PROPOSAL FOR DRAFT AMENDMENTS TO REGULATION No. 107

Transmitted by the Expert from Germany

Figure 10

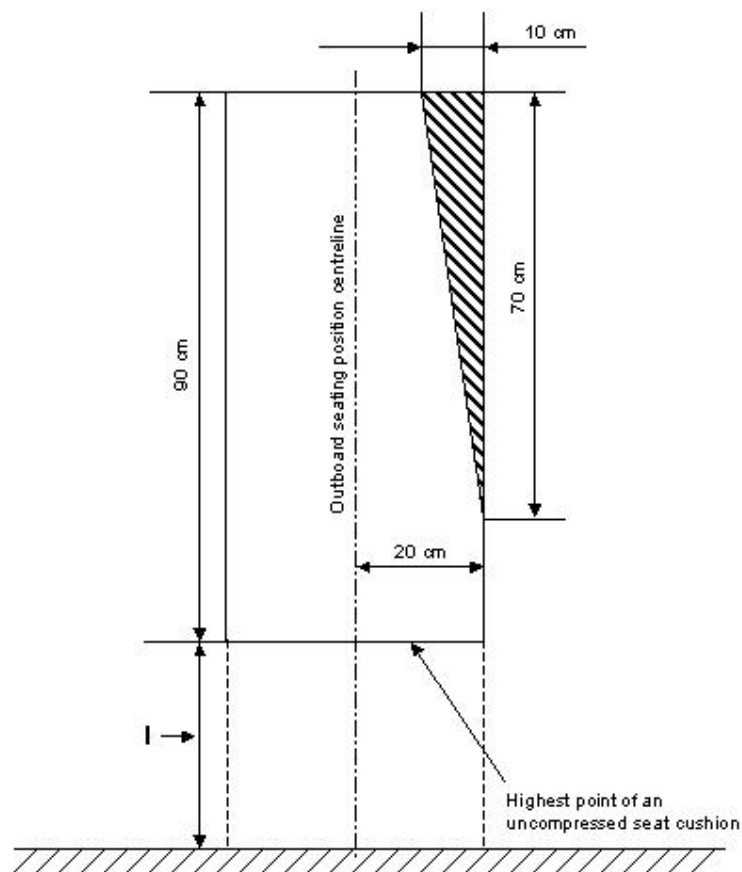
“5.7.9.6.2.2. Intrusion of a structural member provided that the intrusion is included within a triangle whose peak is situated ~~65 cm from the floor~~ **70 cm from the top** and whose base is 10 cm in width and situated in the upper part of the space in question, adjacent to the side wall of the vehicle (see annex 3, figure 10)”

Annex III, Figure 10 amend as shown:

The alteration corrects figure 10.

are transferred to figure 10 to make clear that the general prescriptions of paragraph 5.7.9.3 apply also to paragraph 5.7.9.6.2.2.

As there are different values for „l“ the former method to define the starting point for the triangle representing the permitted intrusion needs to be revised, in order to establish equal conditions for all of the different values. This is achieved by measuring from the top of the minimum height above the seat and leaving the geometry of the triangle unchanged.
